March 3, 2021
10258372

City of Hudson Planning Board
520 Warren Street
Hudson, NY 12534

Re: Verizon Wireless Proposed Rooftop Installation
119 Columbia Street, Hudson, New York 12534
Technical Memorandum

FDV for “Hudson” site’s Alpha sector

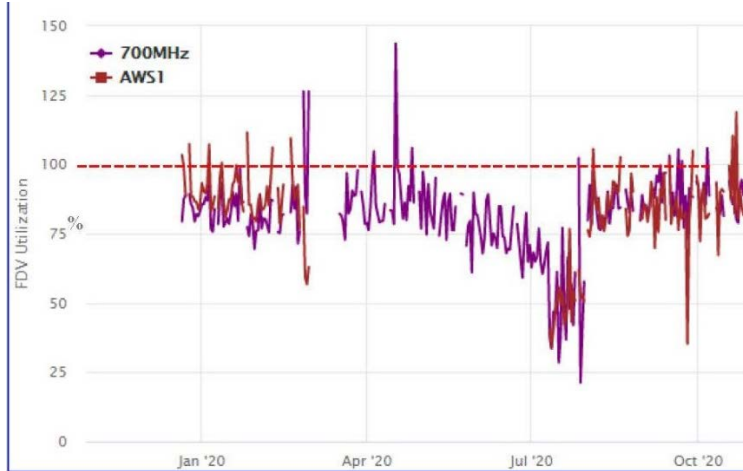
As shown in the images below, for a majority of 2020, the Hudson Alpha sector has been within 75-100% of the FDV utilization threshold, with multiple instances of exceedances. Based on the FDV chart, usage of this existing cell site appears to have decreased during July 2020; the Verizon RF Engineer confirmed that an upgrade was made to the cell site at that time which resulted in a short-term drop in this criterion. The ASEU utilization continuously exceeded the 100% threshold. The AvgAC utilization shows exceedances primarily between late March through June 2020, when the upgrade was made. However, all three capacity indicators are noted to be trending upwards, with one or more frequency bands currently at or exceeding its threshold.

Based on a review of the capacity data, the need for supplemental capacity in Verizon’s local area network has been documented.

Exhibit 1. Existing Verizon Wireless 4G Coverage in Hudson Area

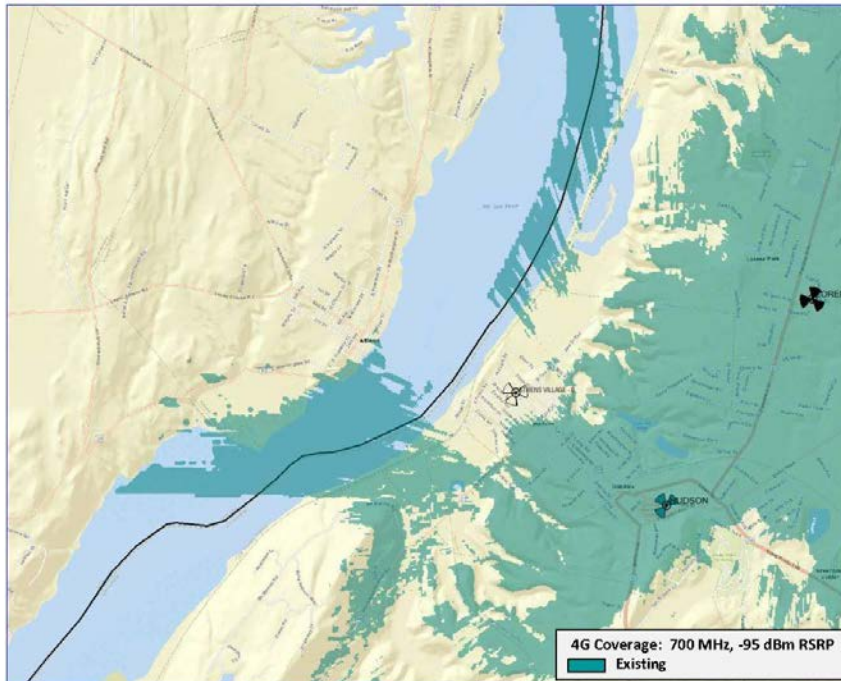
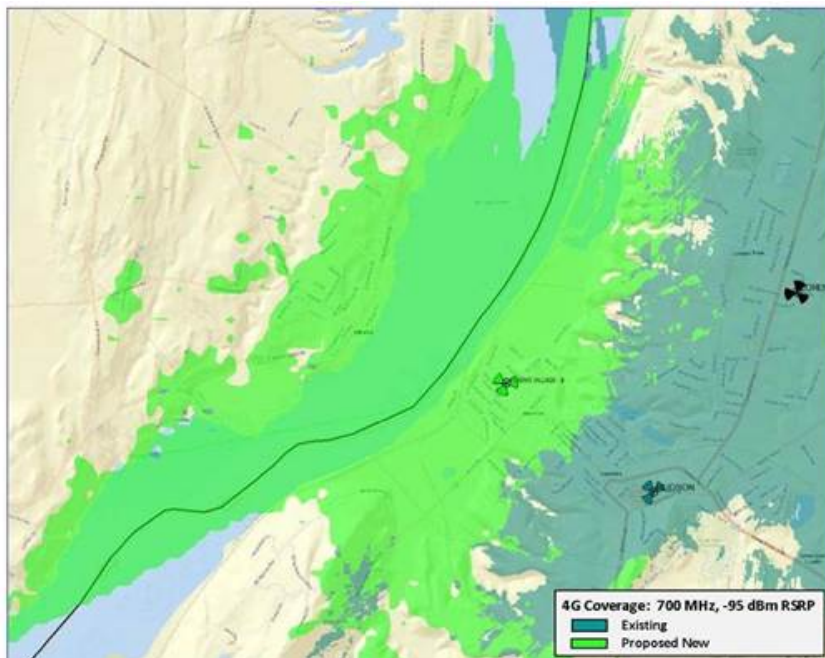
Existing coverage in teal for low-band (700 MHz) frequency, -95 dBm (in-building), 01/30/2020 RF Report. Two existing Verizon cell sites (dark symbols) and 119 Columbia Street (lighter symbol) are included. Note that existing coverage from other area Verizon cell sites was not included in the initial application materials.

“Proposed” coverage, low-band (700 MHz) frequency, -95 dBm (in-building), 01/30/20. The light green color denotes 700 MHz service that will be provided by the proposed facility.

Existing 700MHz Best Server -95dBm RSRP

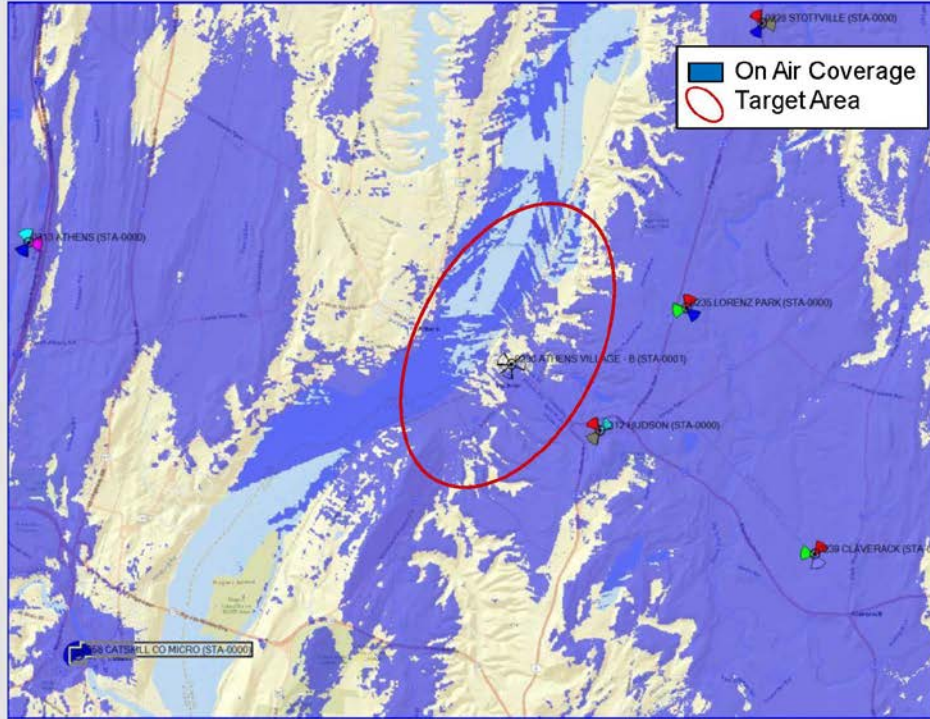
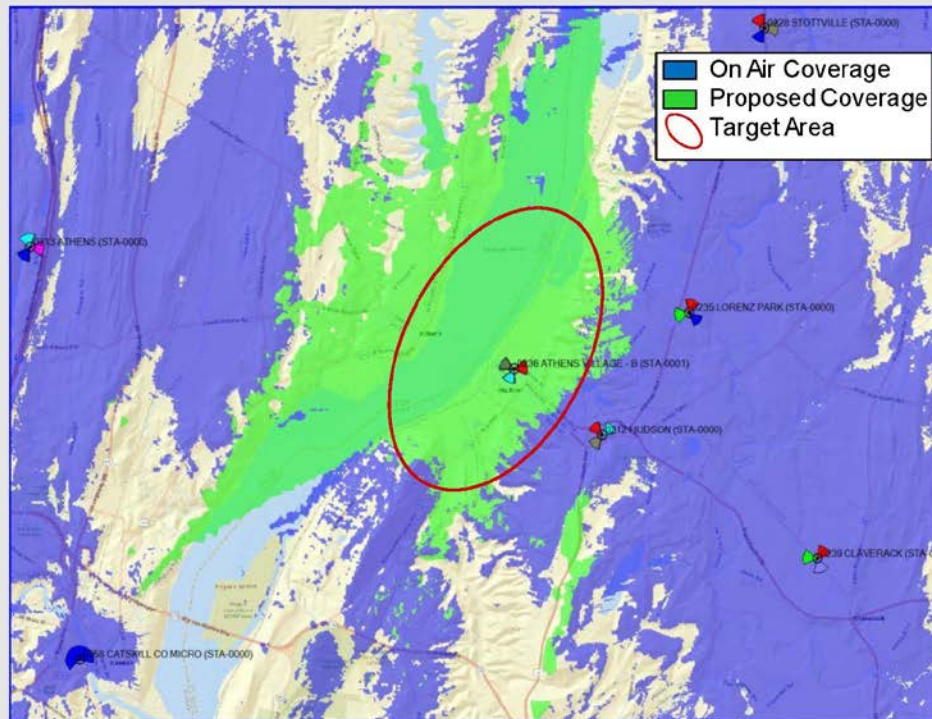
Existing coverage in blue for low-band (700 MHz) frequency, -95 dBm (in-building), 11/4/20. Six existing Verizon cell sites (colored symbols) and 119 Columbia Street (circled in red) are included. This plot is analogous to the existing coverage low band map included above; however, since additional cell sites and their existing coverage plots are depicted, this map is at a smaller scale than the earlier submittal.

“Proposed” coverage (light green) for low-band (700 MHz) frequency, -95 dBm (in-building), 11/4/20. Six existing Verizon cell sites (colored symbols) and 119 Columbia Street (circled in red) are included. This plot is analogous to the above “proposed” low band coverage map, however, since additional cell sites and their existing coverage plots are depicted, this map is at a smaller scale than the earlier submittal.

Existing AWS (2100Mhz) Best Server -95dBm RSRP

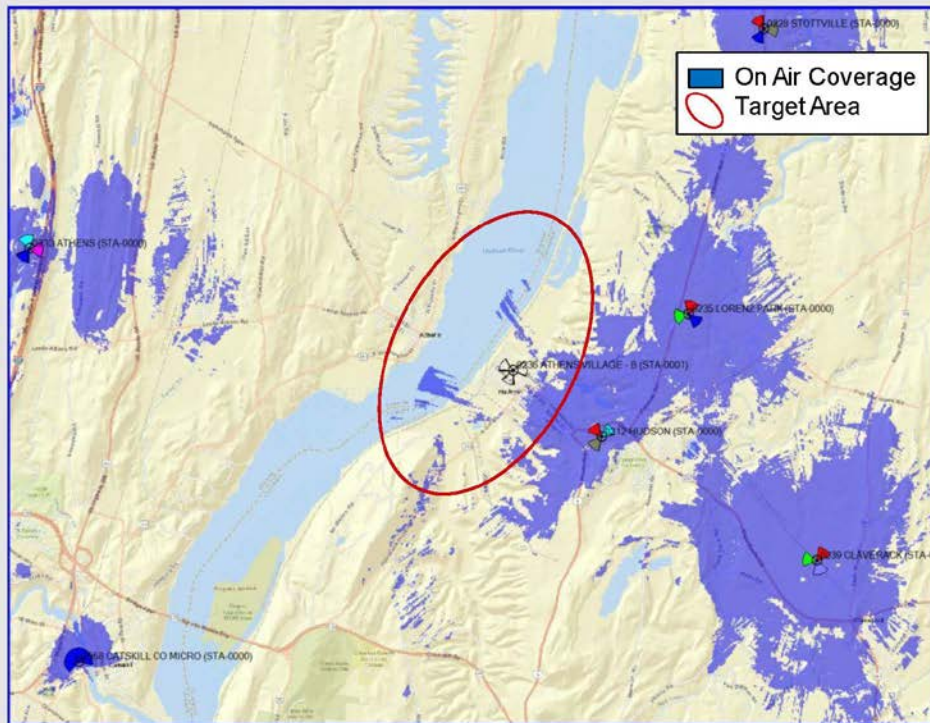
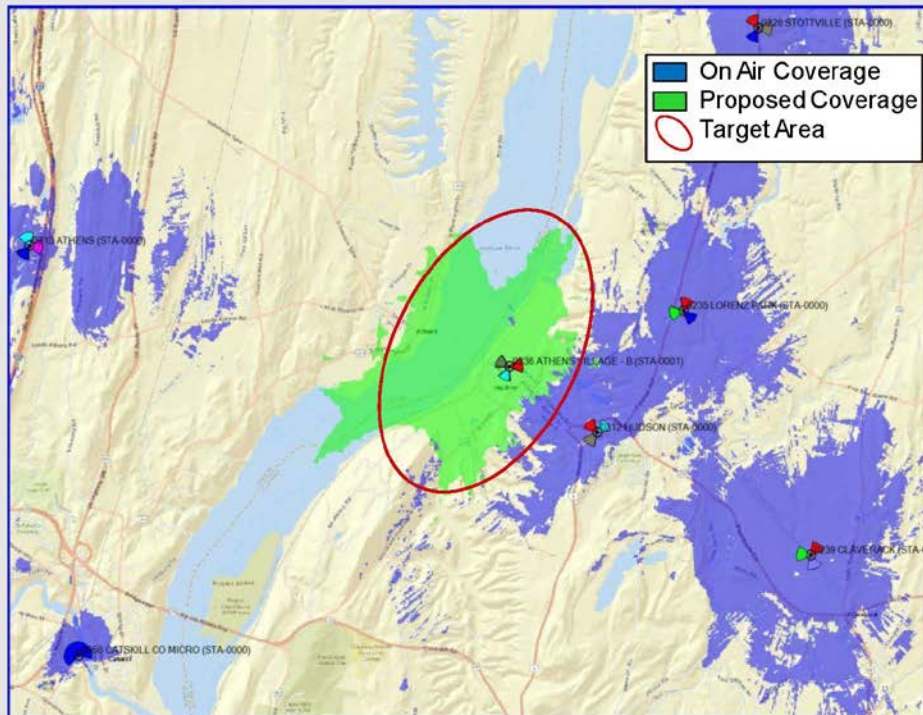
Existing coverage high-band (2100 MHz) frequency, -95 dBm (in-building), 11/4/20. Six existing Verizon cell sites (colored symbols) and 119 Columbia Street (circled in red) are included. 2100 MHz plots were not included in the initial submittal.

“Proposed” coverage high-band (2100 MHz) frequency, -95 dBm (in-building), 11/4/20. Six existing Verizon cell sites (colored symbols) and 119 Columbia Street (circled in red) are included. 2100 MHz plots were not included in the initial submittal. It is noted that coverage footprints for the high band frequency are significantly smaller than those at 700 MHz.

Existing AWS (2100Mhz) Coverage

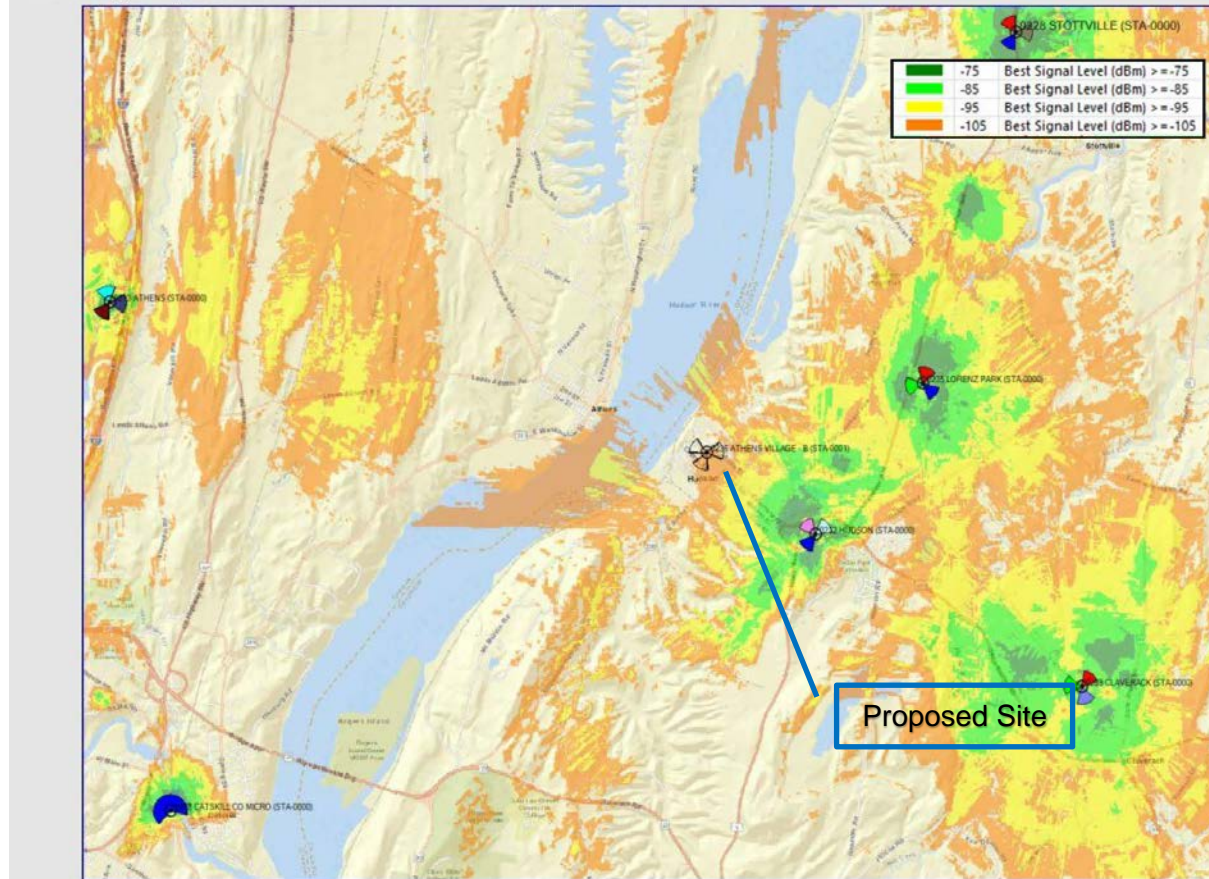
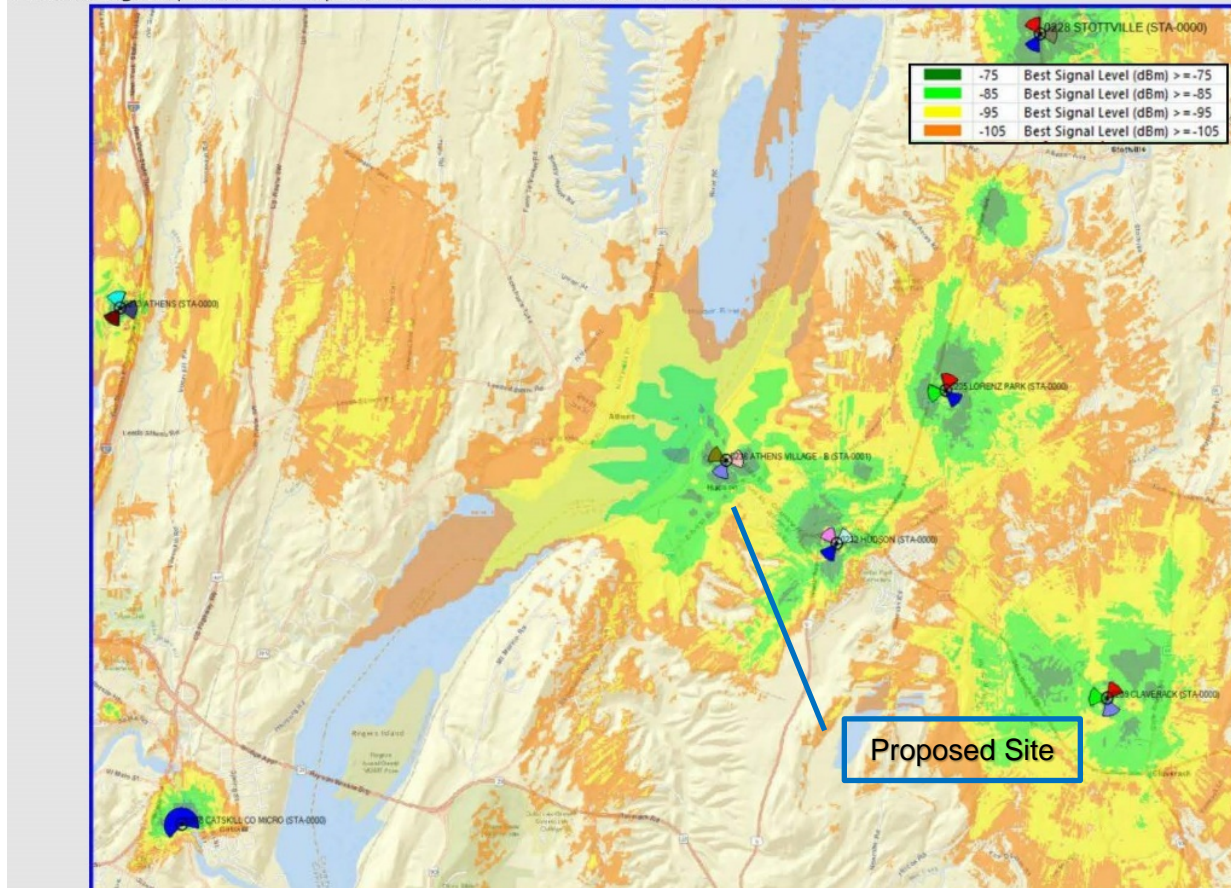
Existing coverage high-band (2100 MHz) frequency, January 2021 submittal. Six existing Verizon cell sites (colored symbols) and 119 Columbia Street are included. This map depicts various signal strengths, including In-Vehicle / Open Space (orange, -105dBm) down to In-Building (-95dBm at green/yellow interface).

“Proposed” coverage high-band (2100 MHz) frequency, January 2021 submittal. Six existing Verizon cell sites (colored symbols) and 119 Columbia Street are included. This map depicts various signal strengths, including In-Vehicle / Open Space (orange, -105dBm) down to In-Building (-95dBm at green/yellow interface). It is noted that coverage footprints for the high band frequency are significantly smaller than those at 700 MHz.

Gaps in coverage have been documented for the City and site area, based on a review of the modeling data and maps provided, particularly for the high band (2100 MHz) frequency. The site at 119 Columbia Street was identified and designed, in part, to provide enhanced low band and high band 4G coverage to the City and surrounding area. If approved and constructed, the proposed Verizon rooftop facility will remedy capacity shortfalls and provide supplemental coverage to the City and site area.

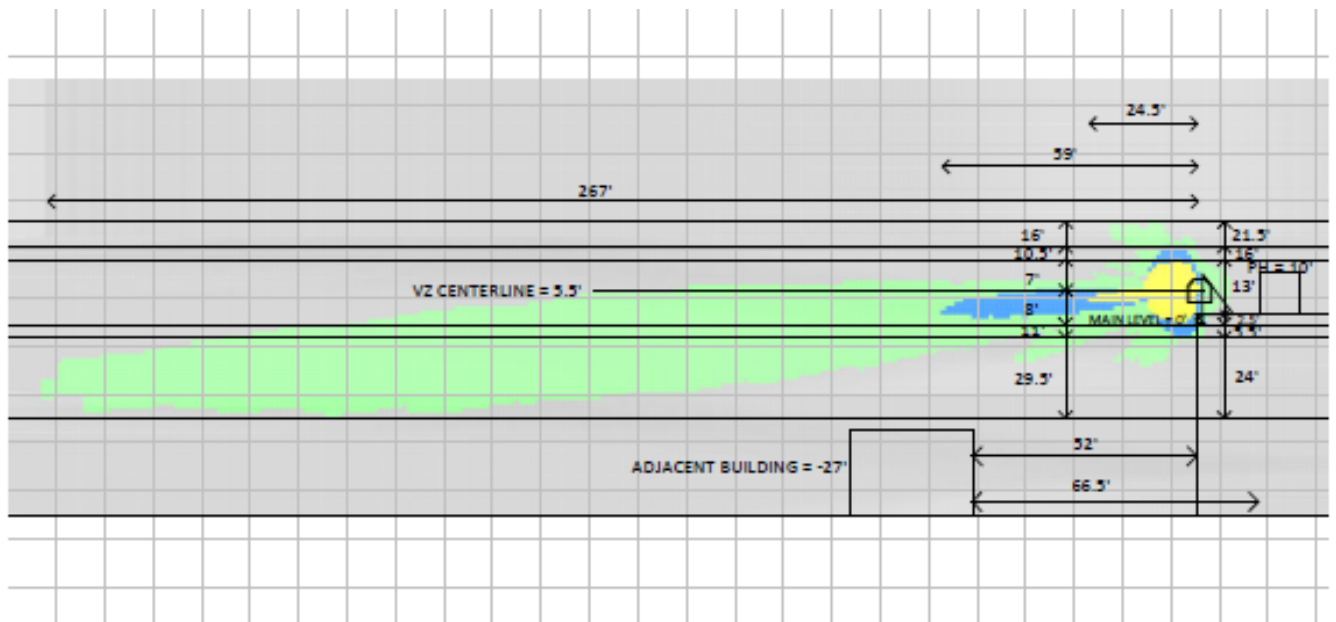
RF Exposure Simulation from Rooftop Antenna Sectors, Plan View of rooftop. Gamma sector (western) at top; Alpha sector (northern) at right; Beta Sector (southern) at left. Grey (unshaded) areas indicate RF levels <5% of the general population MPE limit (on the roof and at off-site areas off of the roofline). Green shading also indicates compliance with the FCC general population MPE limit.

Figure 5 – Proposed Coverage (700 Mhz)

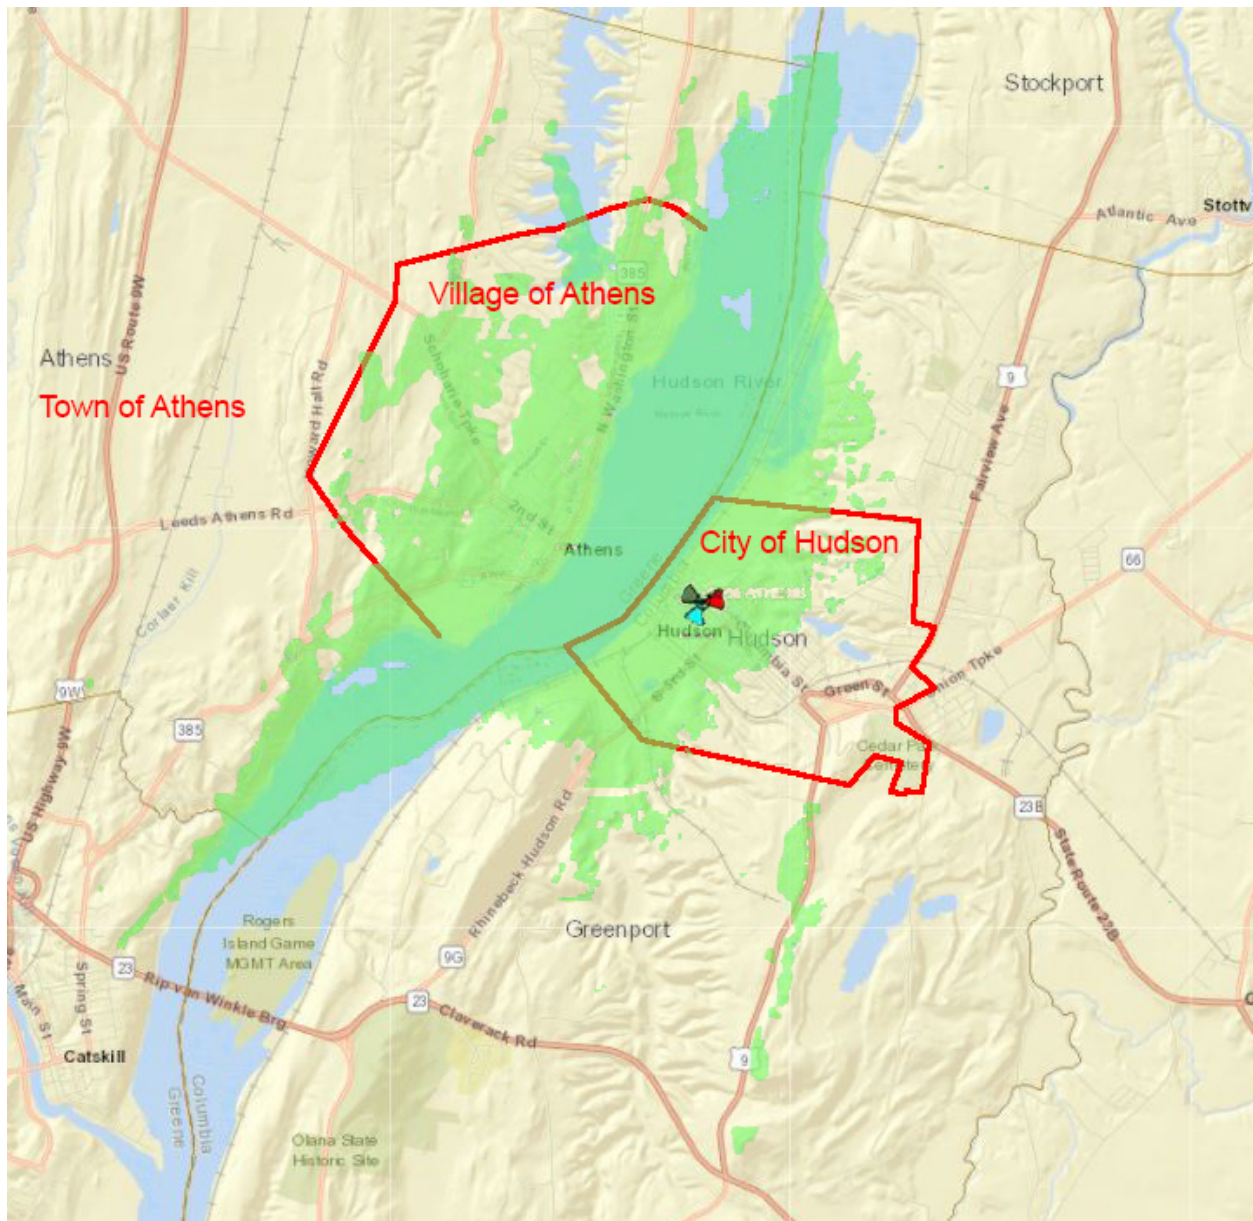
As can be seen in the image below, on a geographic basis much of the downtown commercial, residential, and waterfront areas in the City of Hudson would receive 700Mhz coverage with the proposed site, while approximately three-quarters of the Village of Athens would receive coverage.

It must be noted that Figures 5 and 6 are simple geographic analyses of coverage maps (low band and high band frequencies) overlaid on municipal boundaries. They do not necessarily depict the known capacity issues. As Verizon is licensed by the FCC to operate at both low and high band frequencies, the coverage and capacity data submitted for the 119 Columbia Street application appears to support the statement that service from the site – if approved and constructed – will predominately service the City of Hudson.
